**BP'S RESPONSE TO DEADLINE 3**

## Deadline 3 submission

**BP'S RESPONSE TO THE 24 JANUARY 2022  
NORTHERN ENDURANCE CCUS CO-LOCATION REVIEW REPORT  
PREPARED BY OFFSHORE RENEWABLE ENERGY CATAPULT AND  
NET ZERO TECHNOLOGY CENTRE**

*Example ocean bottom node configuration and illustration of 3D image [GEO ExPro - Ocean Bottom Seismic: Robots on the Seabed](#)*

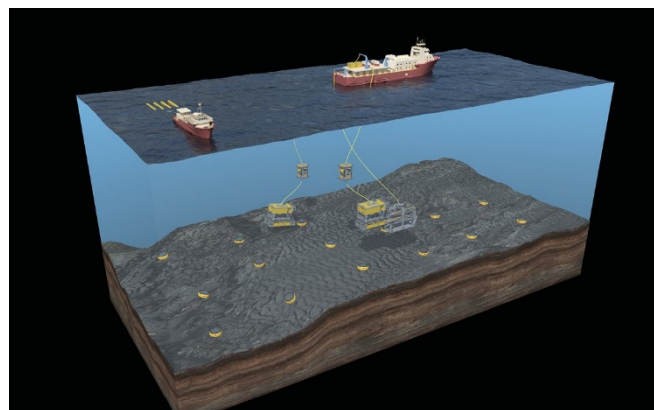
- 2.23.2 The following images (which bp shared with Orsted, TCE, BEIS and the NSTA during a presentation in October 2021) show what OBNs look like and how they are deployed.

- 2.24 If sand waves/tidal currents cause OBNs to move so that they are not in the correct position, it will degrade the resulting quality of the seismic image, as some parts of the geology will be over sampled and others under sampled, and that impacts the amplitude of the response and the ability to analyse the data. This becomes an even greater concern when (as with the Endurance store) time-lapsed 4D occurs (versus carrying out a one-time survey using OBN) because a survey that does not reliably sample all of the geology affects the ability to accurately repeat the survey, which compromises the 4D signal and means it may not be possible to reliably prove containment of CO<sub>2</sub> within the store.

**Figure 1, access requirement 4, shows the minimum area requirements for towed streamer seismic acquisition.**

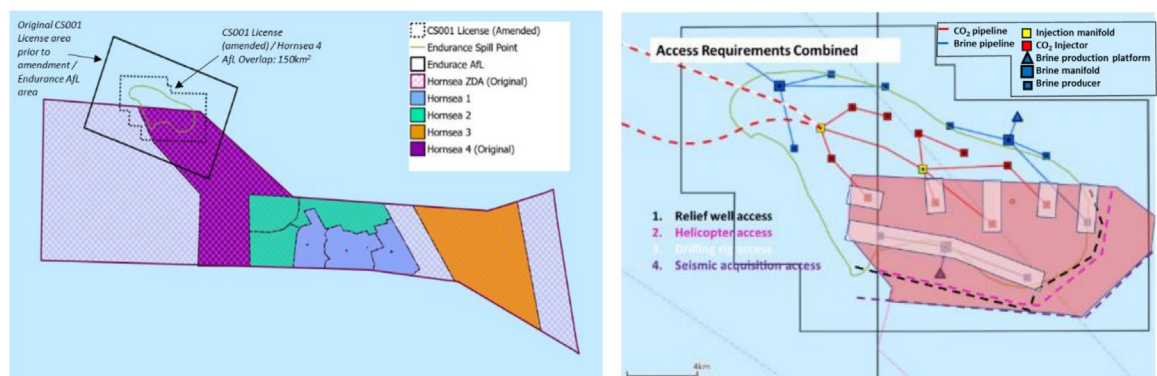
- 2.29 The discussion about ocean bottom instrument and towed streamer seismic monitoring in sub-section 3.3.1 of the OREC/NZTC report does not challenge, question, address or even note the findings and conclusions in bp's Technical Assessment. Those conclusions are that given the characteristics of the Endurance structure and location of the seabed and the regulatory requirement of NSTA that NEP prove containment of CO<sub>2</sub> within the store, repeated 3D towed streamer seismic acquisition over time ("time lapse" or "4D" monitoring) is the best available technology for reservoir monitoring and providing the high quality imaging that is required in terms of the location and containment of the CO<sub>2</sub> plume in the reservoir and confirmation of no leakage into the overburden or beyond the storage site (as described in sections 6.1 and 6.2 of the bp Technical Assessment ([REP1-057](#), Appendix 2, Annex 1 (electronic page number 167))).

**Figure 2** A vertical well is ideal as it will develop a fracture orthogonal to the wellbore no matter what the direction of minimum horizontal stress

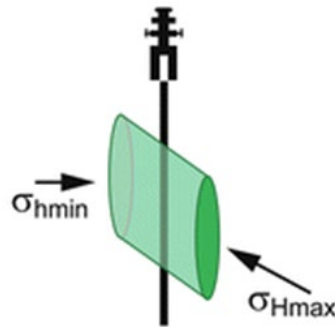
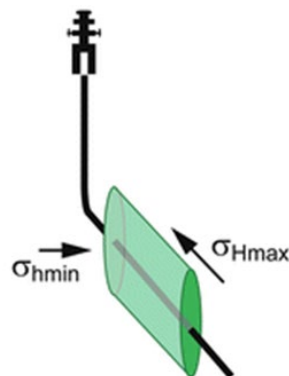
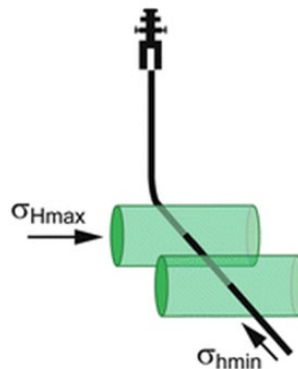
- 4.12 For brine wells, it is likely that a hydraulically-stimulated completion will be required to achieve sufficient rate – this drives a near-vertical profile though the reservoir to be independent of the minimum overburden stress direction. These completions provide an increased surface area for flow, creating a negative skin (increase in effective permeability); however, the orientation of fracture propagation relative to the well bore trajectory is dependent upon the orientation of the in-situ minimum and maximum stress

field. Fracture propagation needs to be near perpendicular to the wellbore which is more difficult to achieve with a deviated well especially if the surface location is subject to constraint relative to the target. This drives the need for a vertical to near vertical well path through the reservoir.

4.13 Page 54 of the OREC/NZTC report recommends that Orsted “*consider Option 2 ... to be the maximum practical offset for a deviated well within the Northern Endurance Partnership CCUS project*”<sup>65</sup>. However, as explained above, the injector wells are, in fact, planned to be vertical wells and not deviated wells.
